Project No. 2021\_154

MIDLOTHIAN ISD STADIUM ADDITIONS AND RENOVATIONS

ADDENDUM NO. 2

DATE: October 18, 2021

M-101

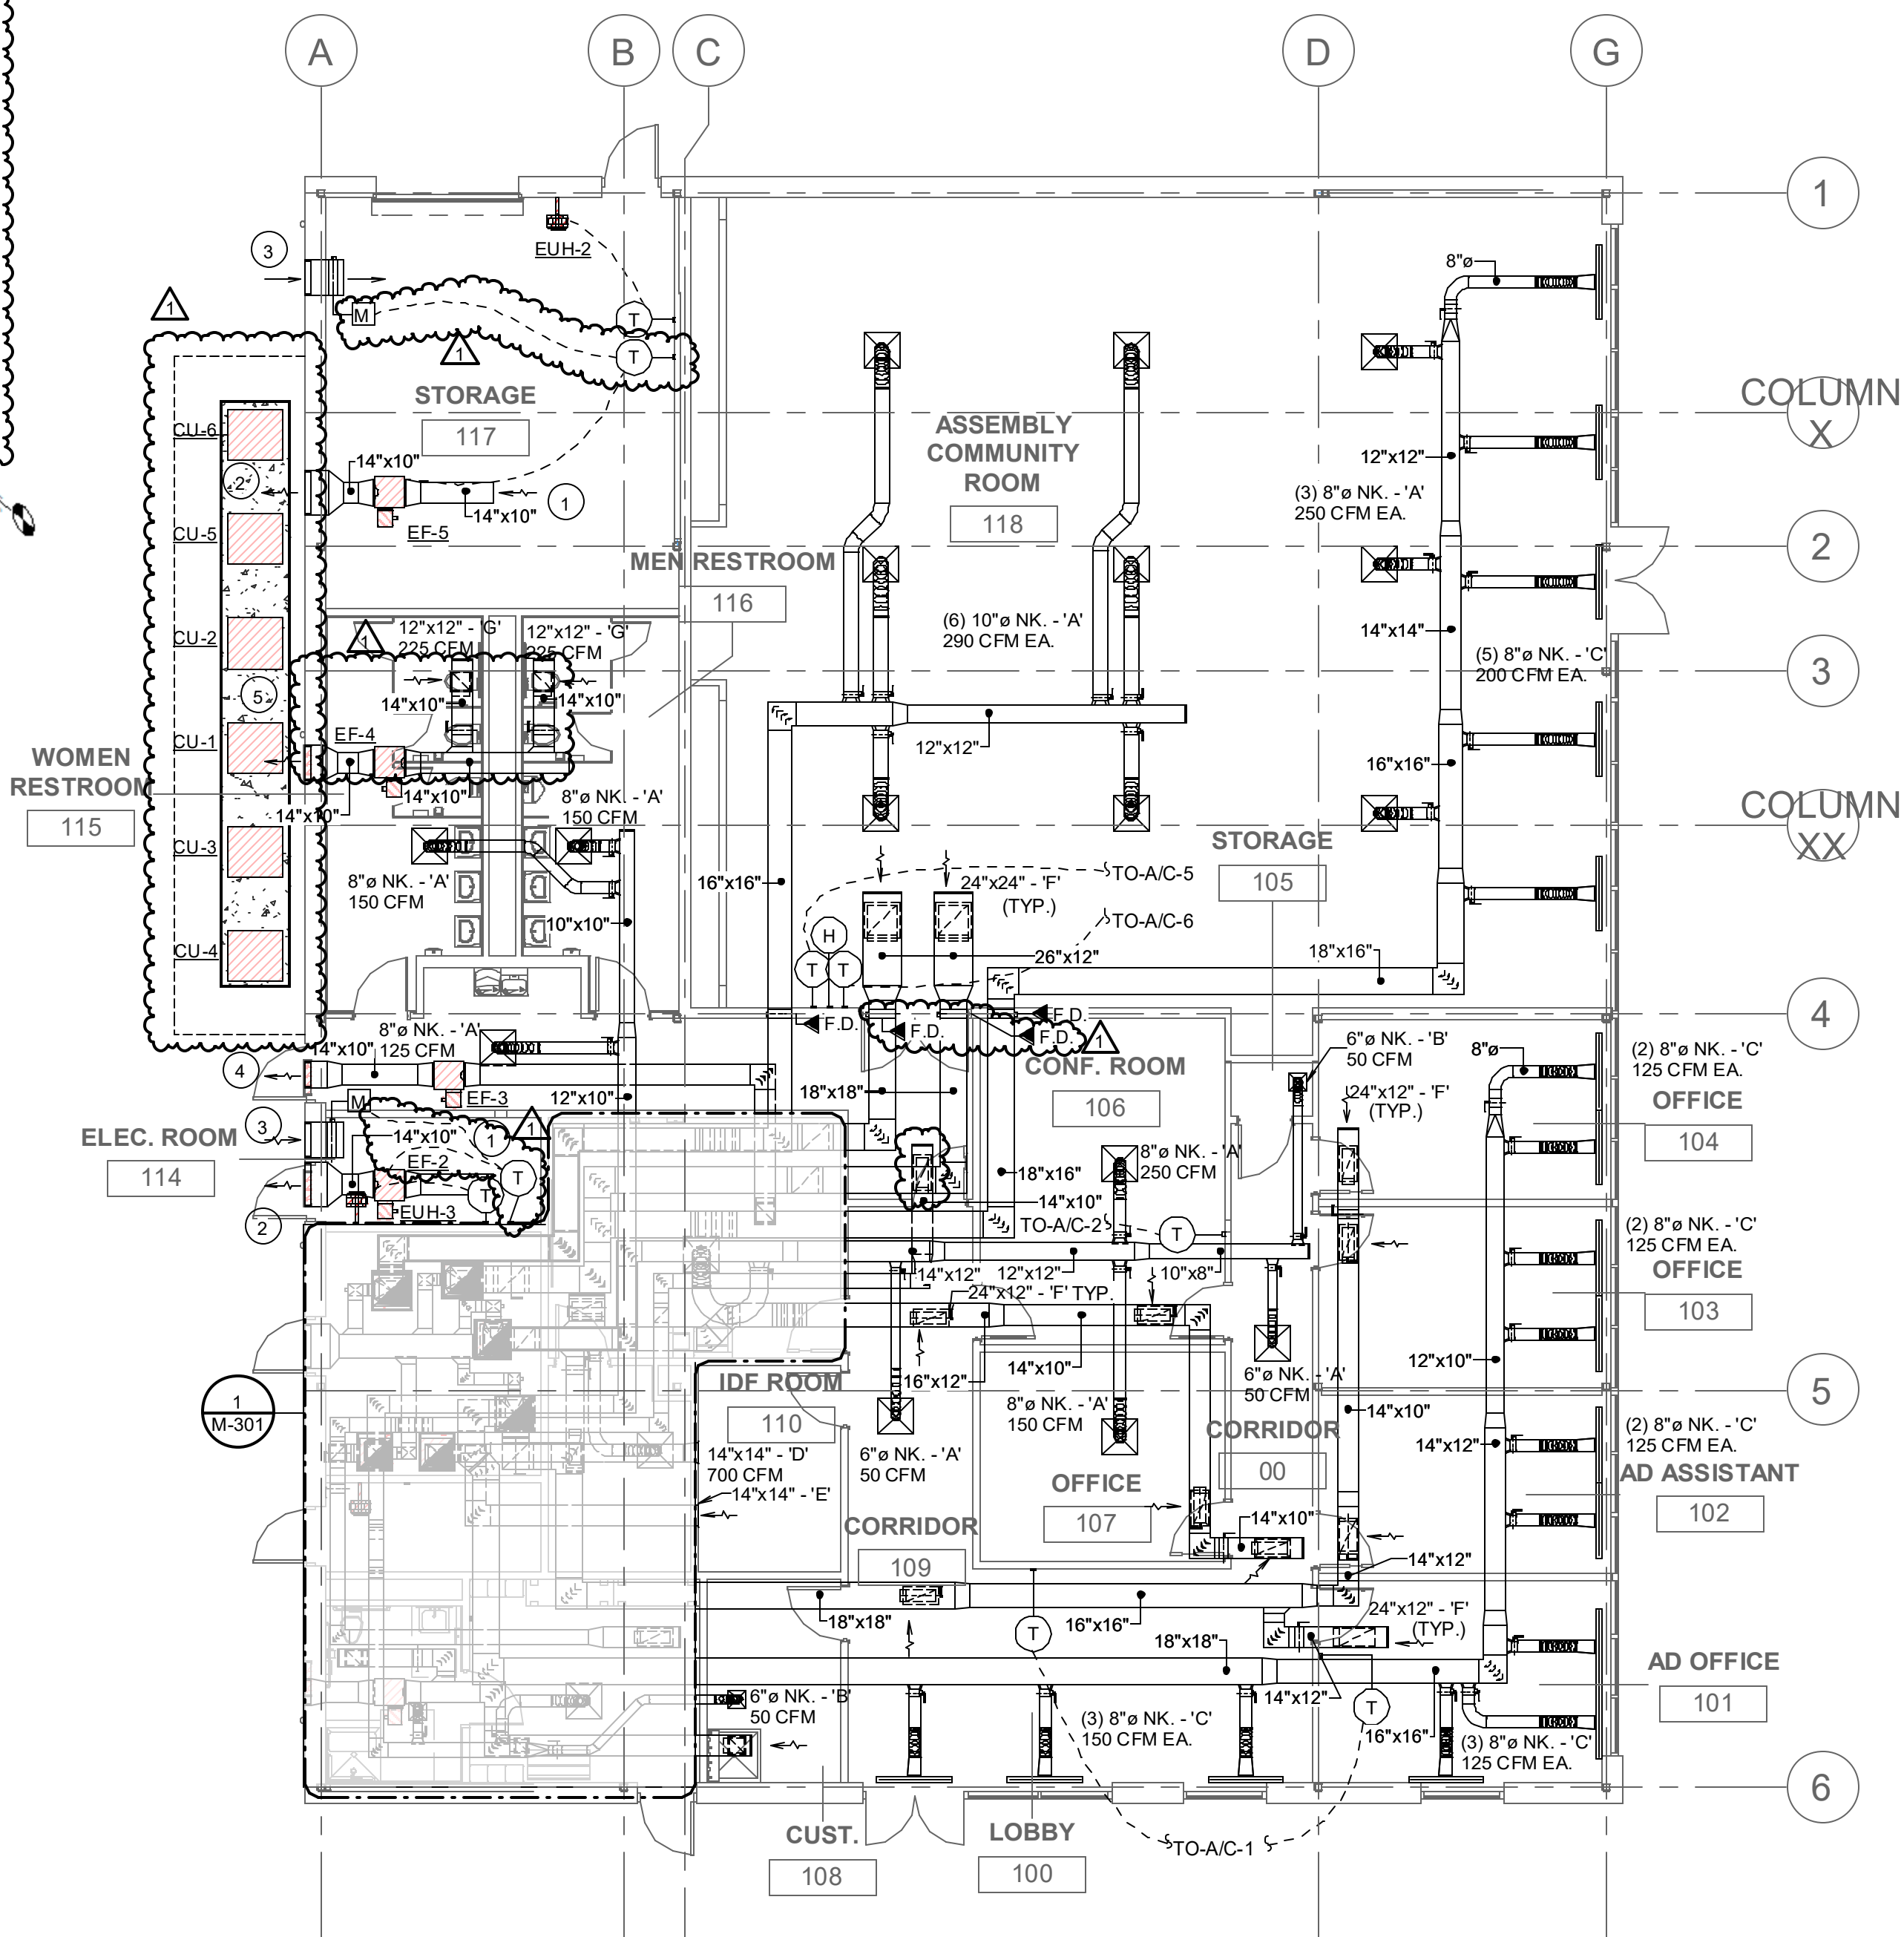
- a. REVISED 'Notes By Symbol' and added thermostat controls in couple of locations as shown on attached drawing.

M-102

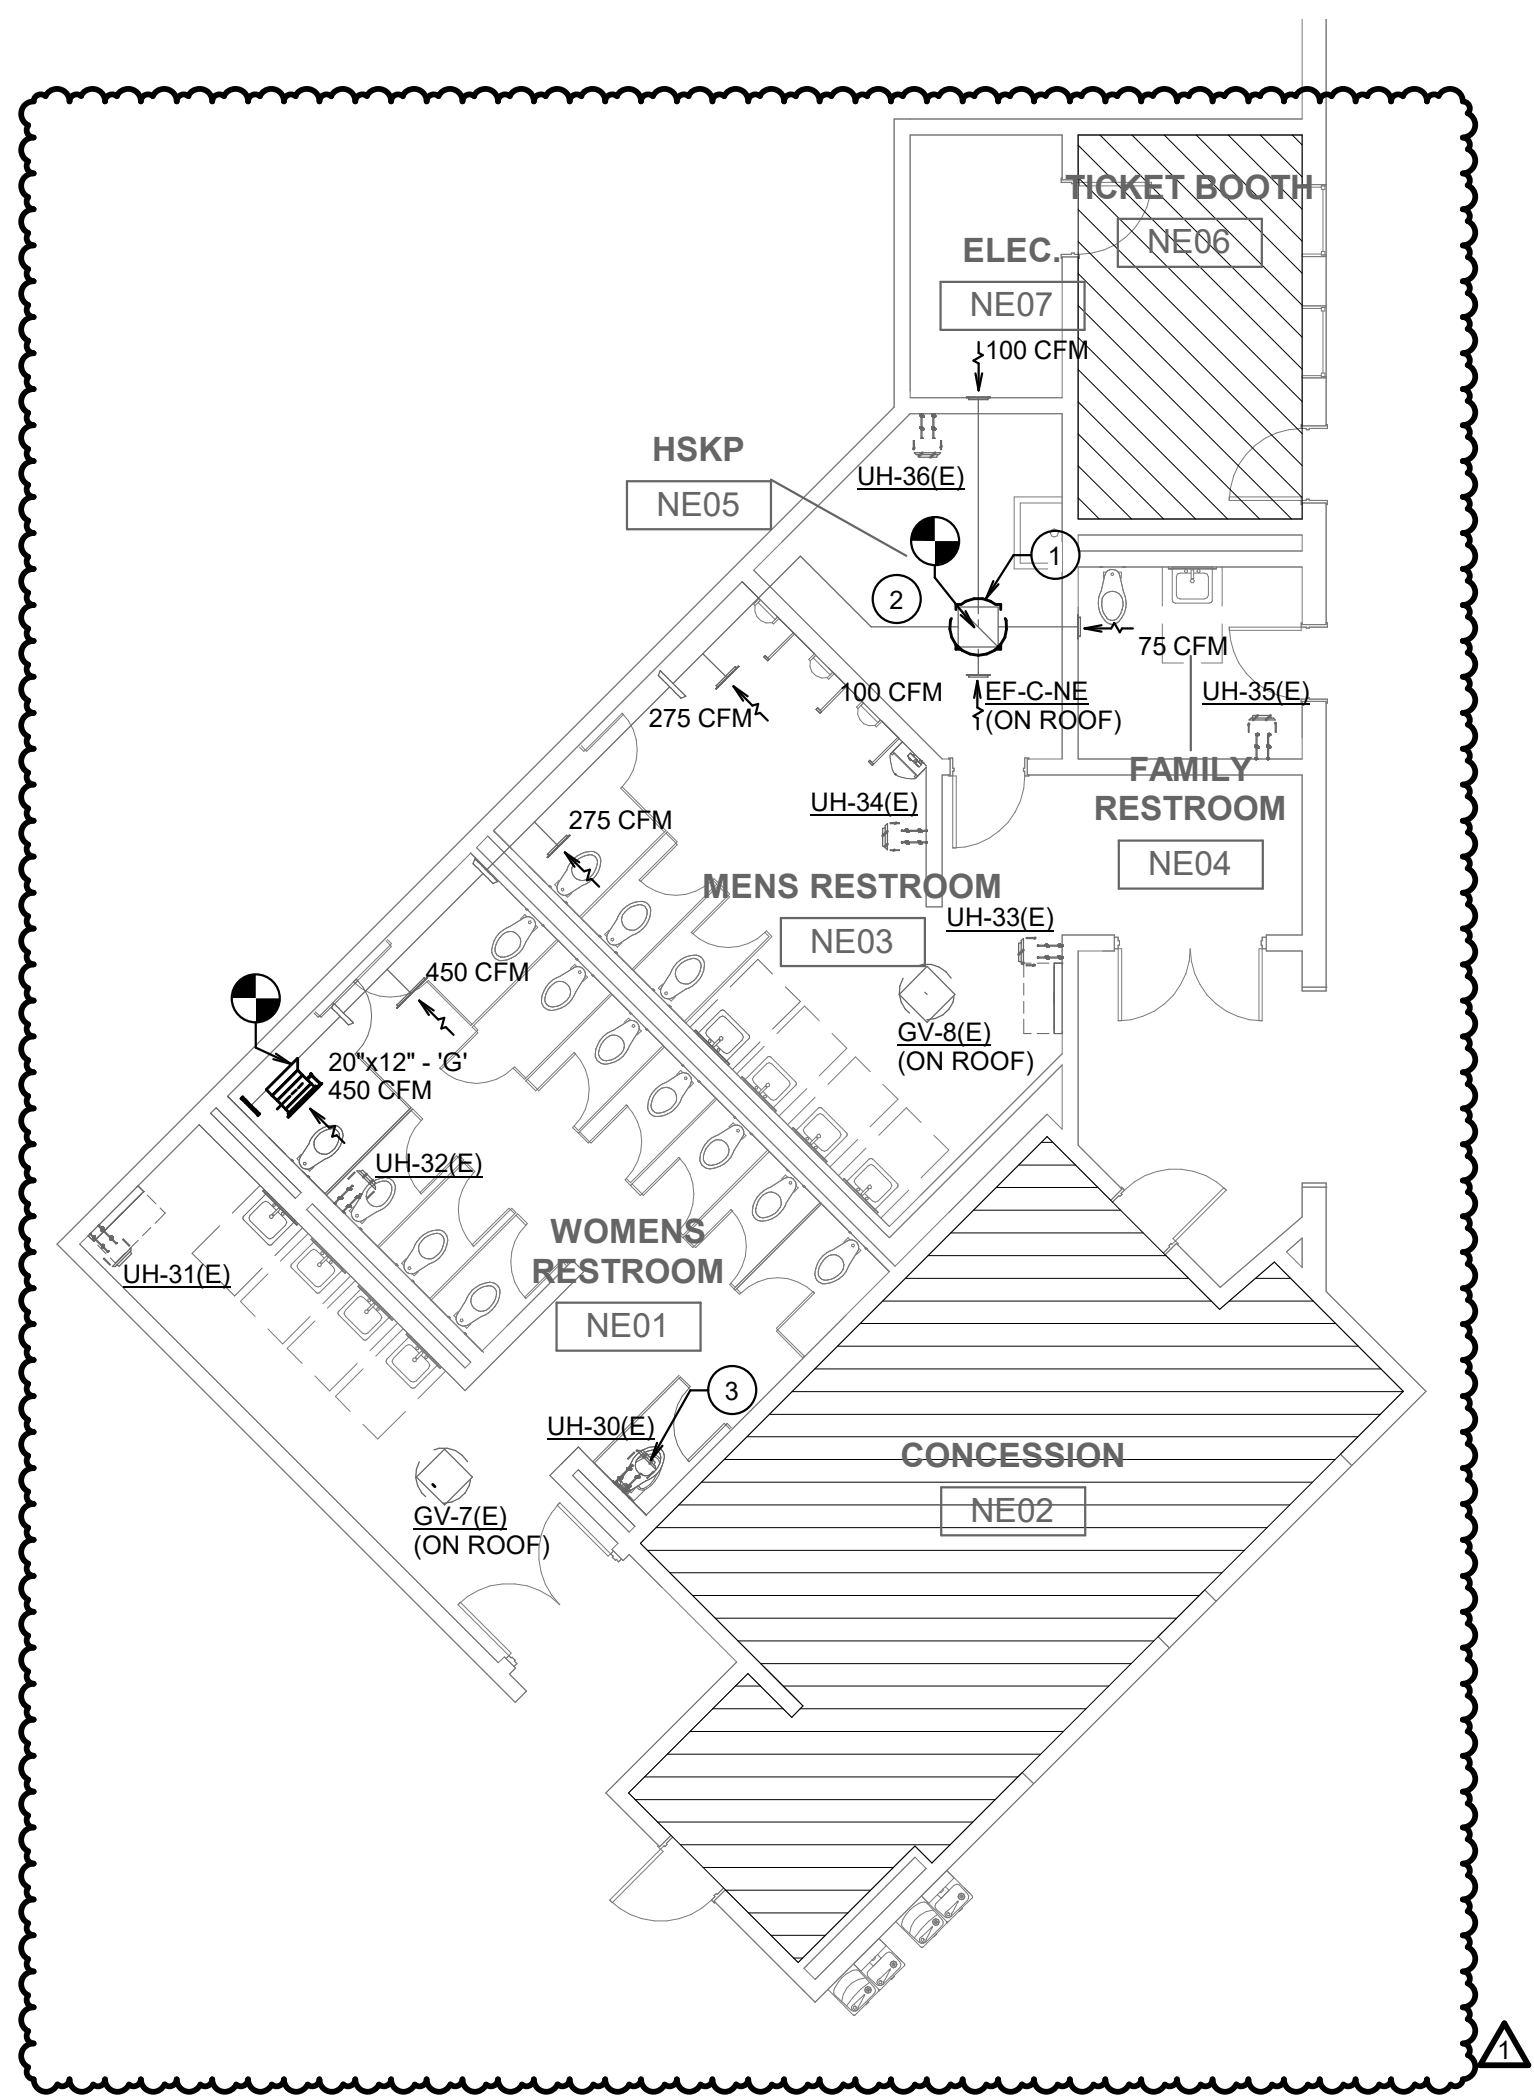
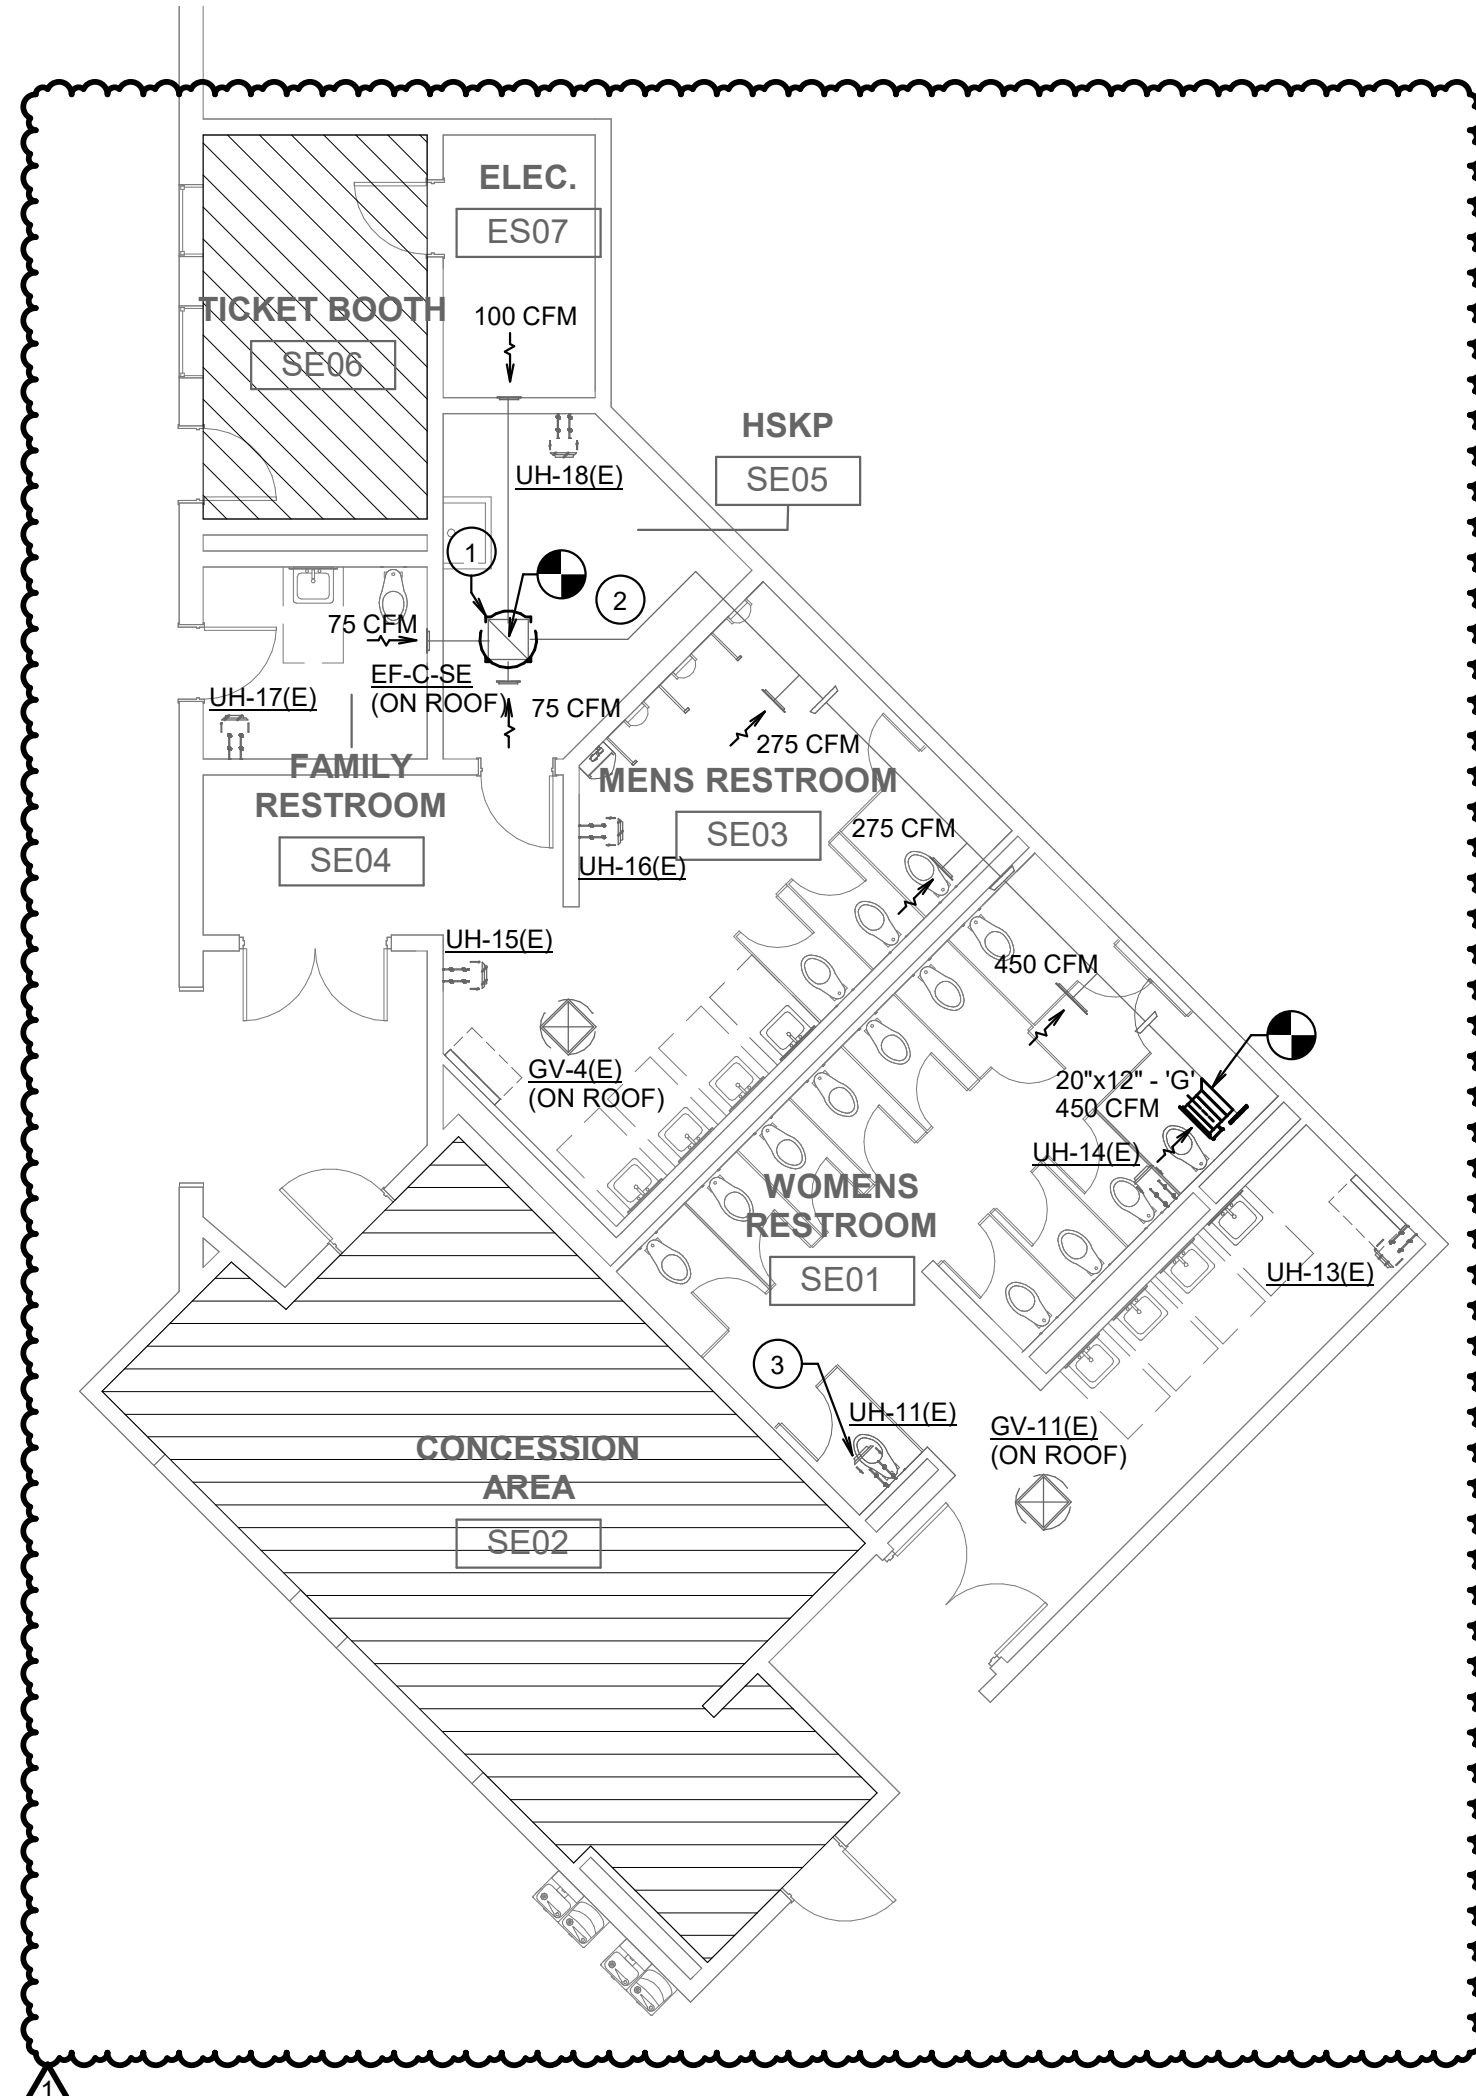
- a. Revised HVAC exhaust grilles tags to clarify the scope of work in each concessions building.
  - b. Revised Exhaust fan schedule and 'Notes by Symbol' as shown on the attached drawing.
